Response to Ofcom on

Consultation and information on technical licence conditions for 800 MHz and 2.6 GHz spectrum and related matters

Nick Long
Great Circle Design
11th August 2011

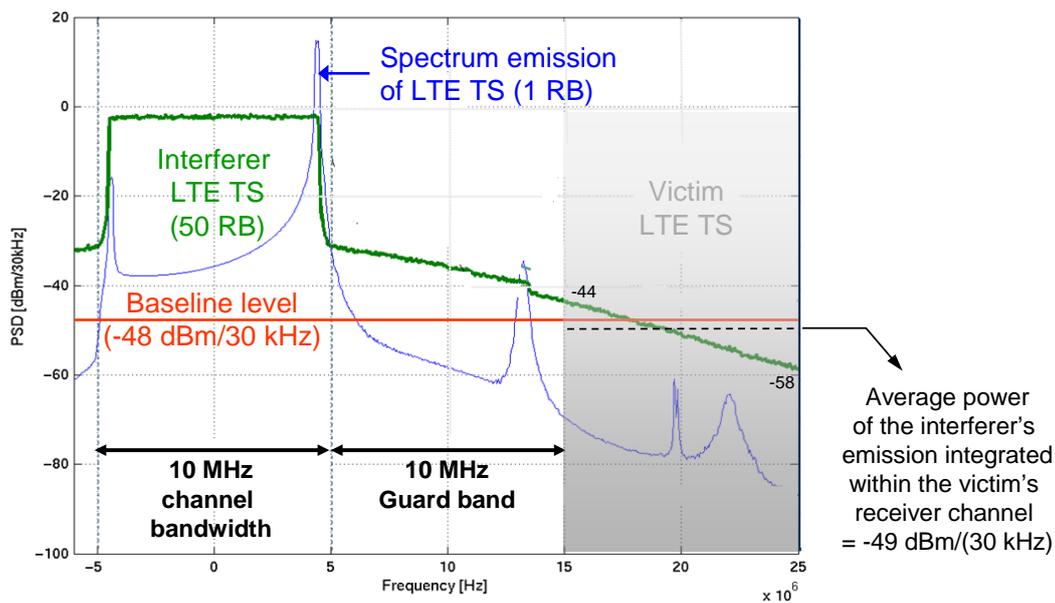
CEPT Report 30, Figure 5, shows an emissions mask for a handset TS, which is reproduced below. This is an assumed Block Edge Mask (BEM) when operating with 1 RB and 50 RB.

This BEM indicates that a TS in the top 10 MHz block will put an out of band emission of approx -40 dBm into a 15 kHz receiver bandwidth at 869 MHz. This would happen all across the SRD band if it were running 50 RB, or on certain channels if it were running 1 RB.

The recently published Harmonised Standard for LTE handsets, EN 301 908-13, however, sets different parameters. This permits -11.5 dBm/1 MHz emissions at 869 MHz. If this were evenly spread as noise it would be -21.5 dBm in 100 kHz or -29.7 MHz in a 15 kHz bandwidth.

By contrast I note that under EN 300 220 an alarm system at 869 MHz is only permitted OOB emissions into the LTE band of -54 dBm/100 kHz, an imbalance of over 32 dB.
